PCN Title: Qualification of Additional Clip Bonding, Lead Frame Structure (Matrix) and Mold Compound for Select Automotive Products in SMA Package

**PCN-2543 REV 1**

Figure 1: Comparison of Package Construction for GPP Rectifiers and Unidirectional TVS products

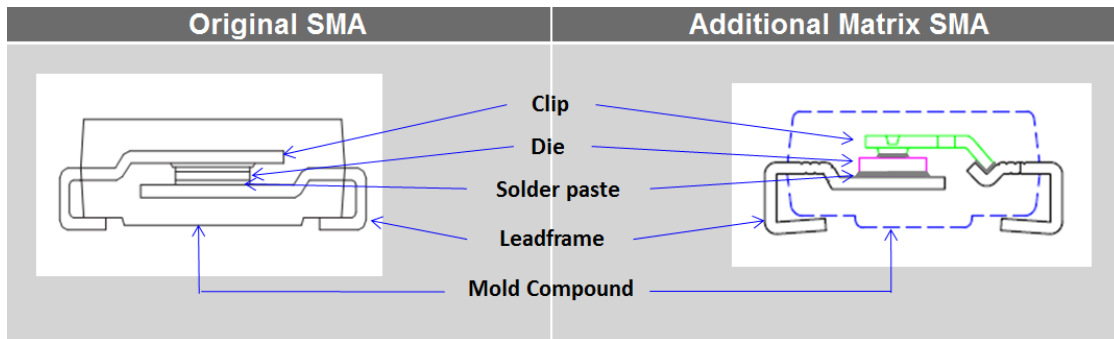
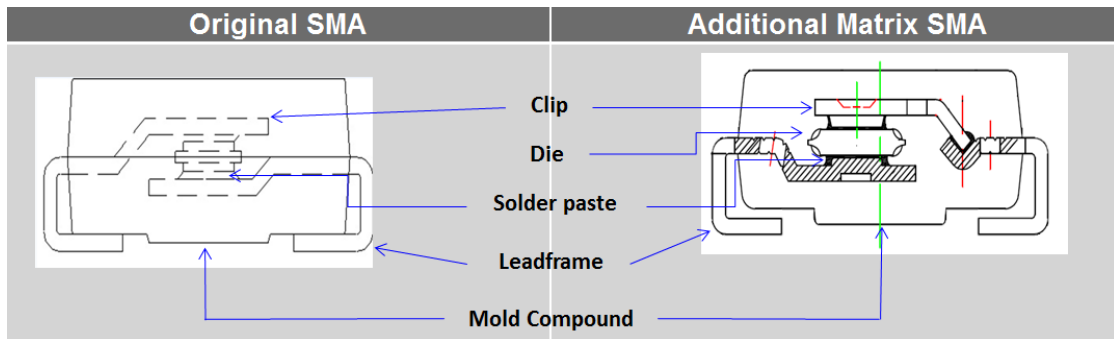
This PCN is being issued to notify customers that in order to assure continuity of supply and to improve SMA package manufacturability, Diodes Incorporated has qualified additional clip bonding, lead frame structure (Matrix) and mold compound at Diodes subcontractor Eris Technology Corp. (ERIS) in Taiwan for select Automotive products in SMA package.
